STATE OF CONNECTICUT  
CONNECTICUT SITING COUNCIL

PETITION NO. 1590

November 9, 2023

**RESPONSES OF TOWNORTH DEVELOPMENT, LLC AND NEW CINGULAR WIRELESS PCS, LLC TO CONNECTICUT SITING COUNCIL INTERROGATORIES**

SHEET NUMBER  
**Z-1**

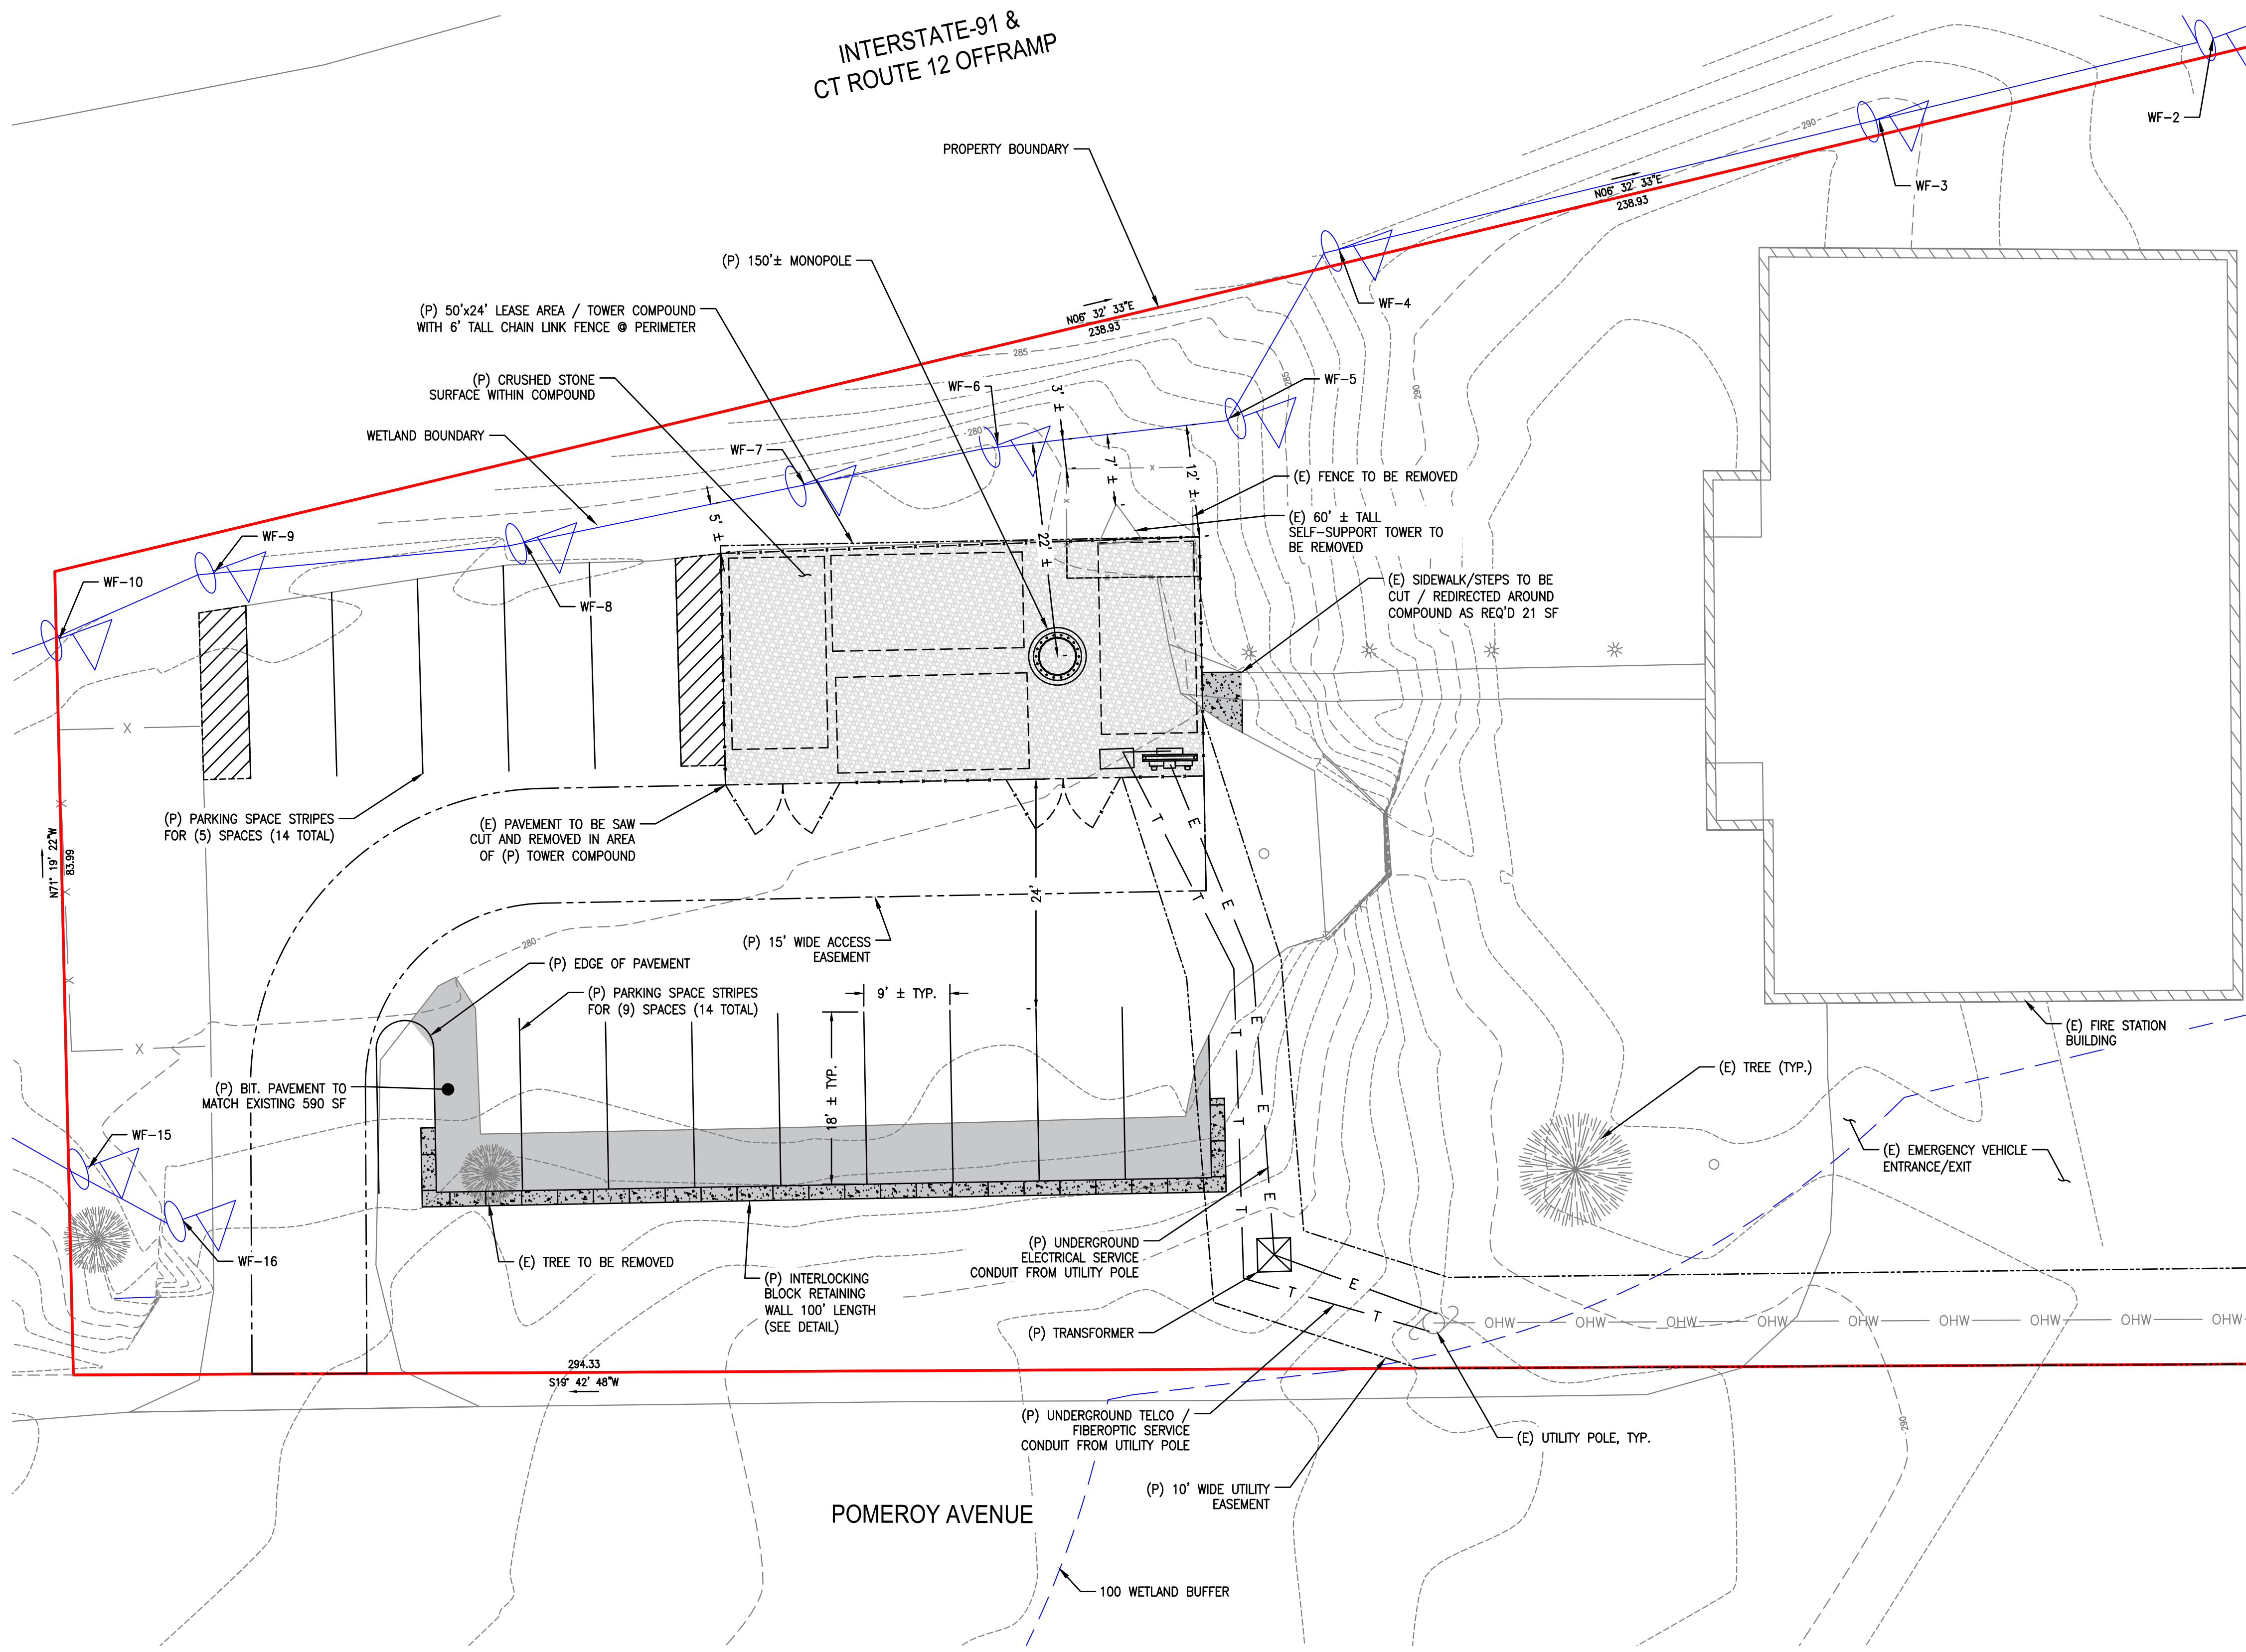
- Q24. Referring to Petition page 2, the fenced equipment compound would be 1,684 square feet. According to Sheet Z-1 of the site plan provided in Petition Attachment 2, the fenced compound dimensions would be 24 feet by 50 feet (1,200 square feet). Sheet Z-2 provided in Petition Attachment 2 shows the fenced compound as a 25-foot by 50-foot (1,250 square feet) area. Please clarify.

Q53. Referring to Petition page 3, no trees would be removed for the construction of the proposed facility. However, Sheet Z-1 shows an existing tree to be removed. Please clarify.

- A24. *The lease area will be 25'x50' (1,250sft) and the fenced compound will be approximately 1,230sft as the compound fence is not rectangular. The drawings were updated to clarify this item. The updated drawings are included in **Attachment 2**.*

- A53. *One (1) existing tree is to be removed as part of the parking lot expansion required.*
- Q54. Referencing Attachment 4 of the Petition, Viewshed Map, describe the change in visibility, if any, of the proposed replacement facility versus the existing tower in the surrounding area.
